Removal Action Work Plan (Revision 1)
PCB TSCA Waste
Building 3, St. Louis Army Ammunition Plant
Contract No. DACW41-00-D-0019

This letter transmits Revision 1 of the Removal Action Work Plan for PCB TSCA Waste at Building 3, Saint Louis Army Ammunition Plant, St. Louis, Missouri. A distribution list for the Work Plan is attached.

To minimize photocopying and binding expenses, we are submitting only those portions of the Work Plan that have been modified or updated since the draft submittal. Revisions to the Work Plan are based on reviewer comments (received as of October 29, 2001) and internal peer review. The following inserts or replacement pages/text are included with this Revision 1 submittal:

- Replacement binder cover and spine
- Replacement text (all) to Work Plan
- Replacement tables (all) to Work Plan
- Replacement figures (Figures 3-1, 3-10, 3-11, and 3-12 only) to Work Plan
- Replacement cover and introductory text to the SAP (Appendix A of the Work Plan)
- Replacement text (all) to Field Sampling Plan, Part 1 of the SAP (Appendix A of the Work Plan)
- Replacement forms (select forms) from Appendix A of the FSP, Part 1 of the SAP (Appendix A of the Work Plan)
- Repla

Figure 3-10
Hoist Ring and Lift Cable Detail

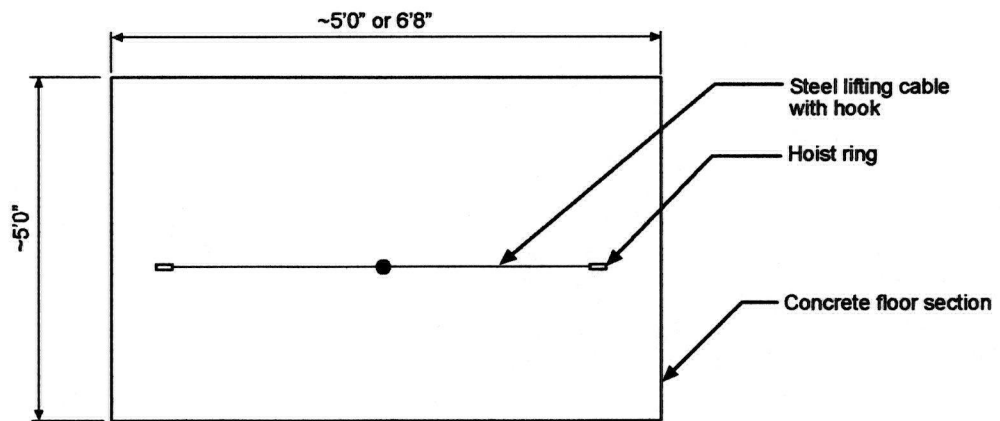
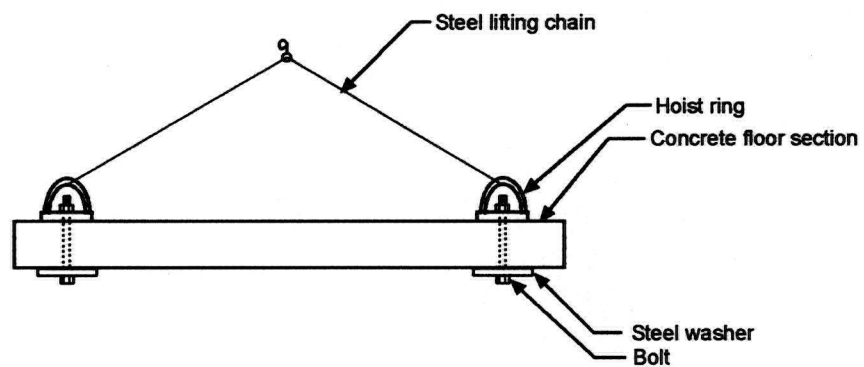
- Core two holes through the concrete flooring and install hoist ring assembly as shown in Figure 3-10. To provide underlying support for the flooring in areas where horizontal I-beams are not present, stage shoring will be erected beneath each slab to be removed (refer to sketch contained in Appendix D). The hoist rings will be installed prior to construction of the shoring.

- Core two holes through the concrete flooring and install hoist ring assembly as shown in Figure 3-10.
- Cut concrete around the perimeter of the slab and around building columns with a pro-grade diamond blade mounted to a hydraulically-operated walk-behind concrete saw. To prevent the accumulation of exhaust gases inside the building, the saw shall be powered by a diesel engine stationed outside the building or a scrubber will be used to minimize carbon monoxide emissions. Clean water will be used to cool the blade during cutting. The slurry (cooling fluids mixed with concrete dust) generated during concrete cutting

Figure 3-11
Cut Detail for Concrete Supported
by Horizontal Floor Beams

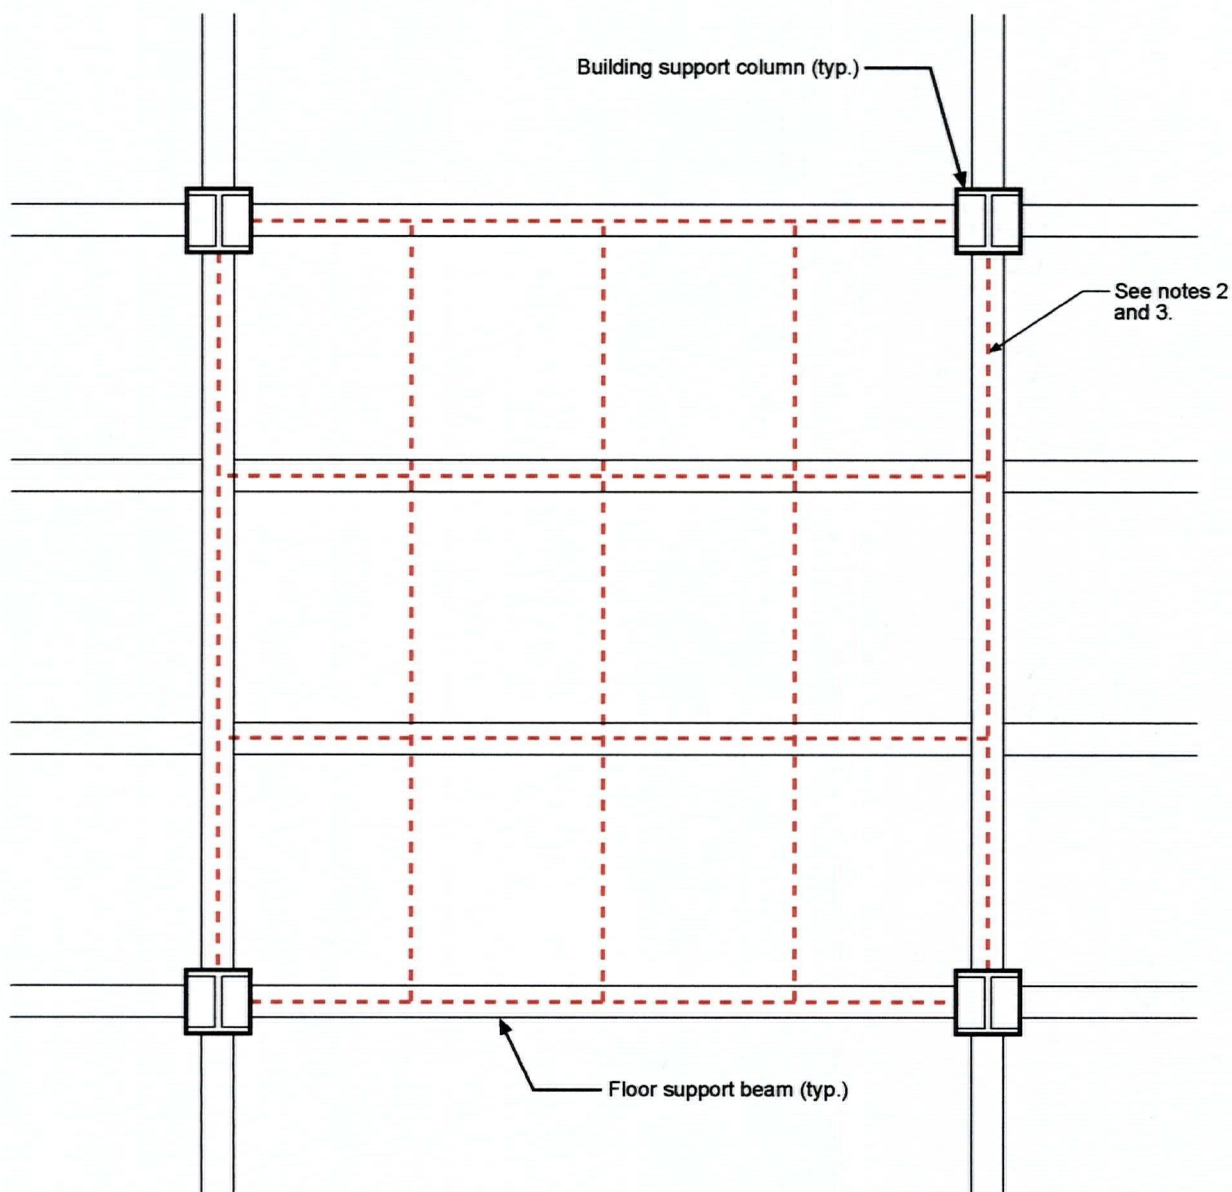
will be collected with a Shop-Vac and containerized in 55-gallon drums. [Note: A sample of the cooling fluids will be collected and analyzed for PCBs at the onset of the cutting operation to determine if further containerization of the fluids is warranted. The containerization of the slurry will not be required if the PCB concentration in the sample of the slurry is below the action level.] The concrete flooring in will be cut as detailed in Figure 3-11.

SHORING @ 1ST FLOOR THICK SLAB AREA

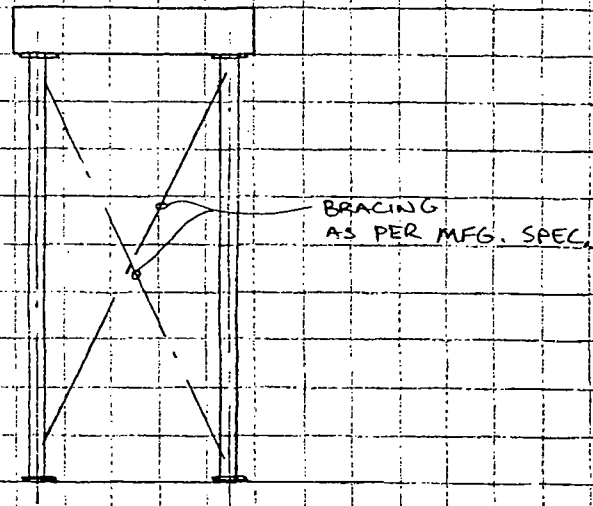
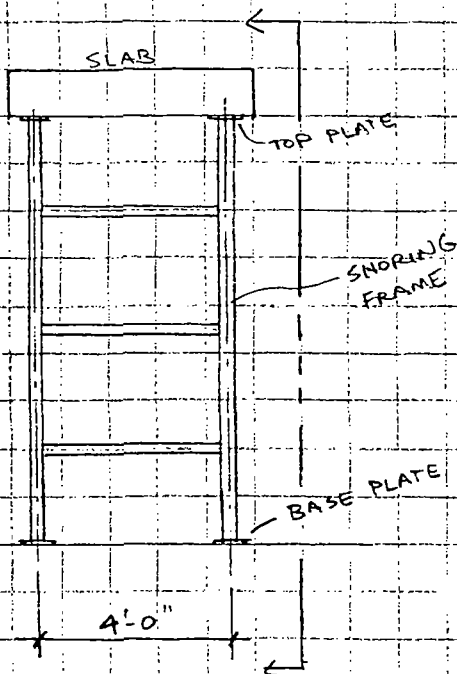
Finally, sheet 16 shows typical shoring required at the thick slab area for each slab section that is to be cut.
